SEWAGE DISPOSAL SYSTEM

MARYLAND STATE DEPARTMENT OF HEALTH

ADDRESS 7311 Brangles Road, Marriottsville, Md. 21104

ROAD 13049 Triadelphia Mill Rd, Lot

HOUSE LOCATION DRAWING

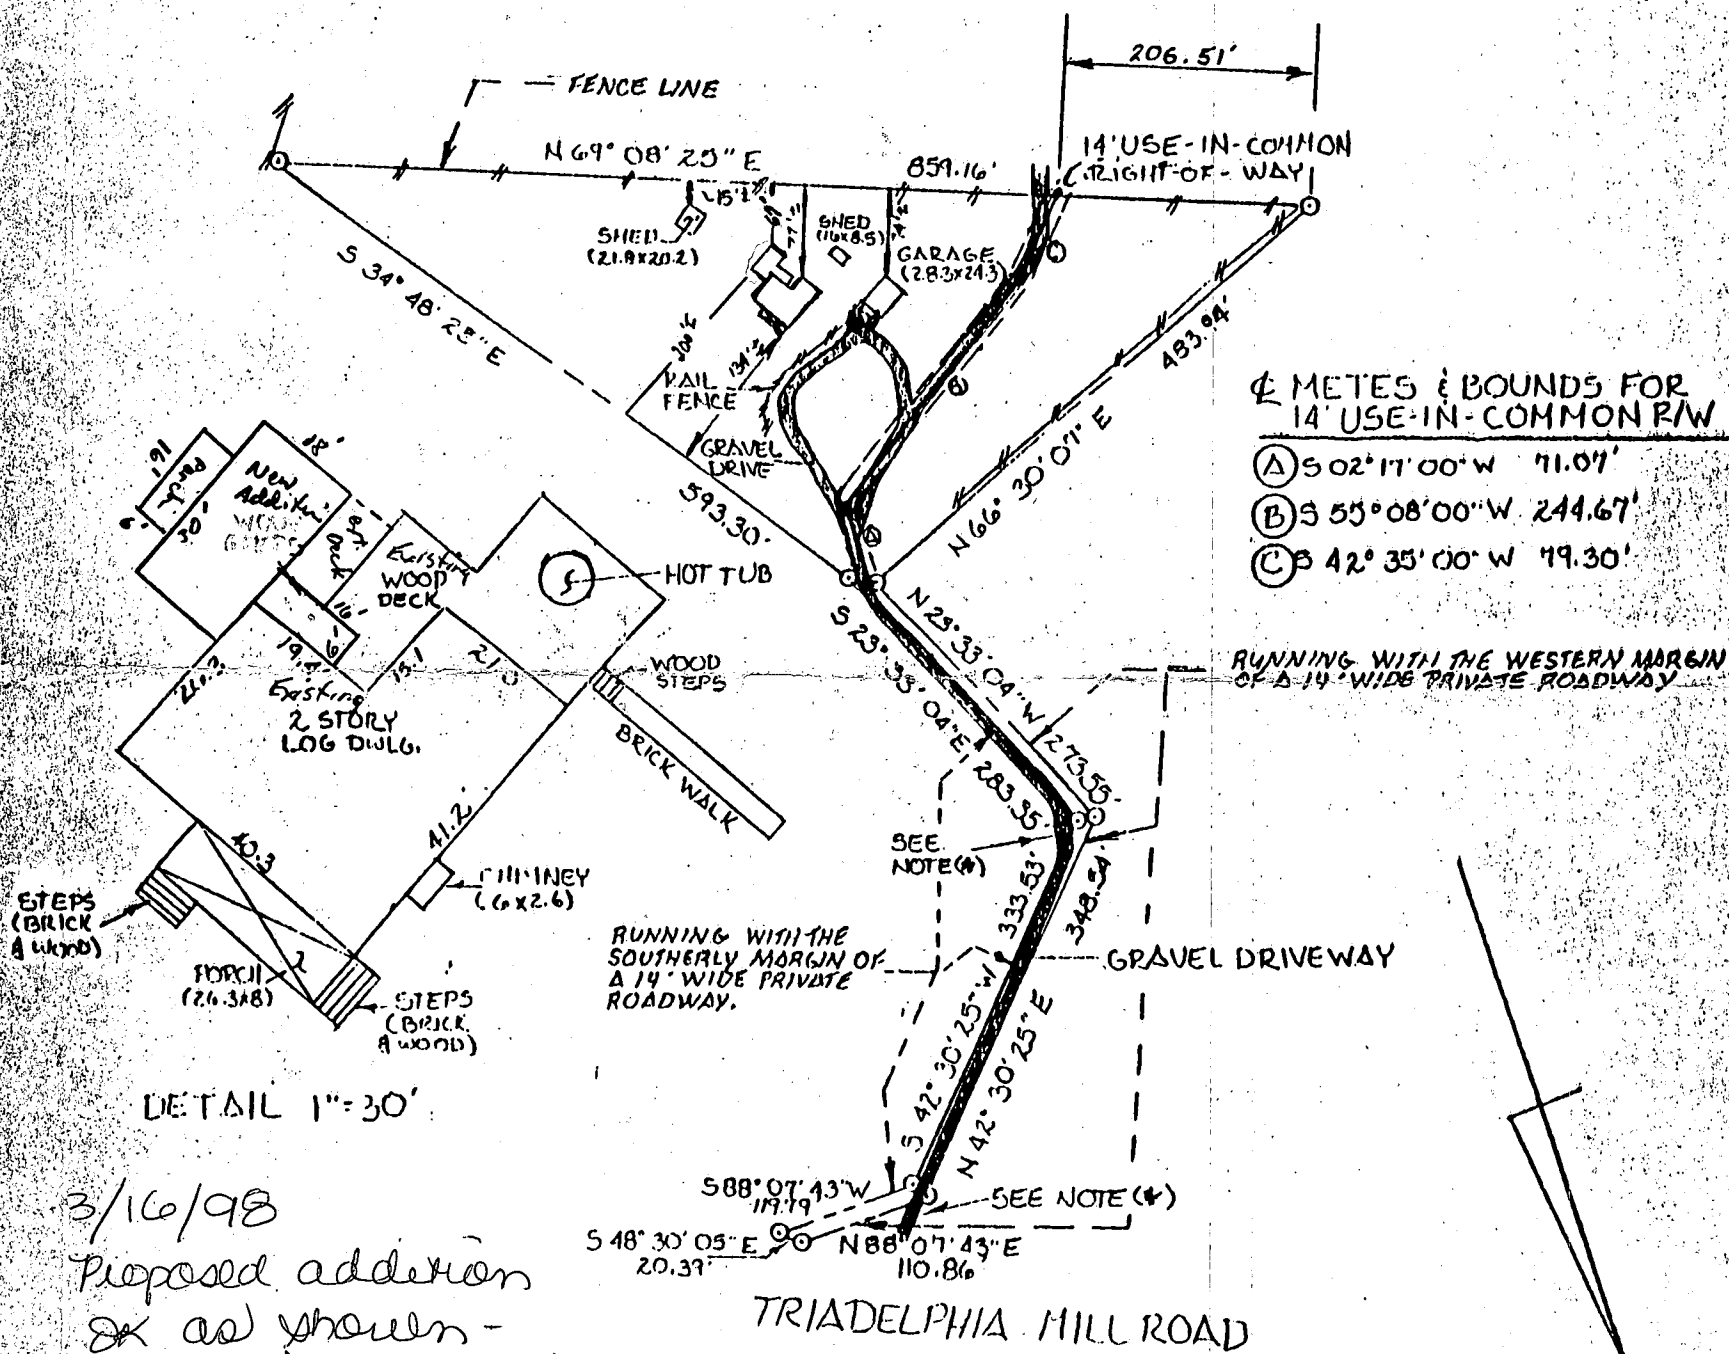
3/16/98
Proposed addition
~~OK~~ as shown -
no septic upgrade
required at this time.

LOCATION DIAGRAM

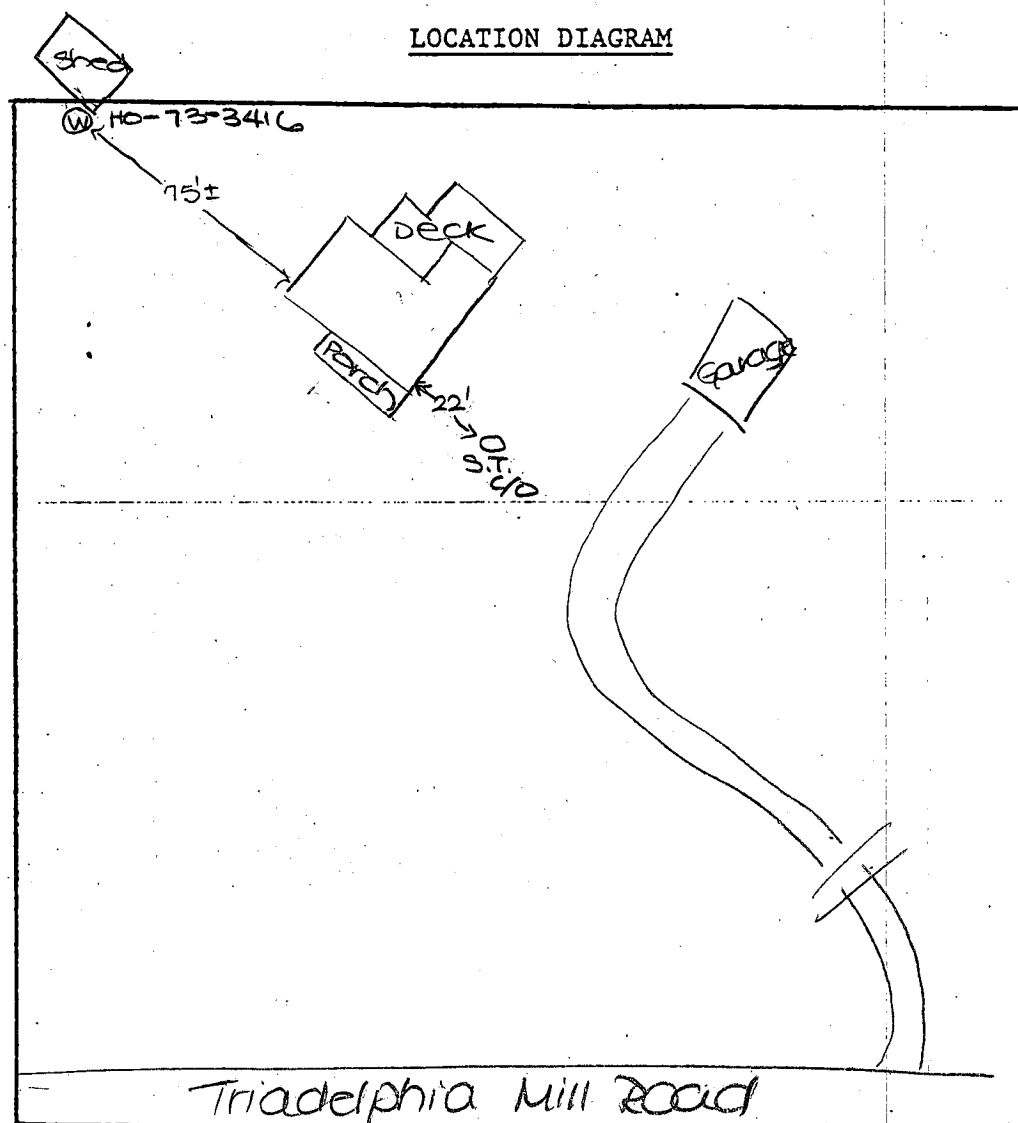
COMMENTS: Existing well and septic tank located. Unable to
determine type of drainfields(?) currently serving property.
(Owner not at site)
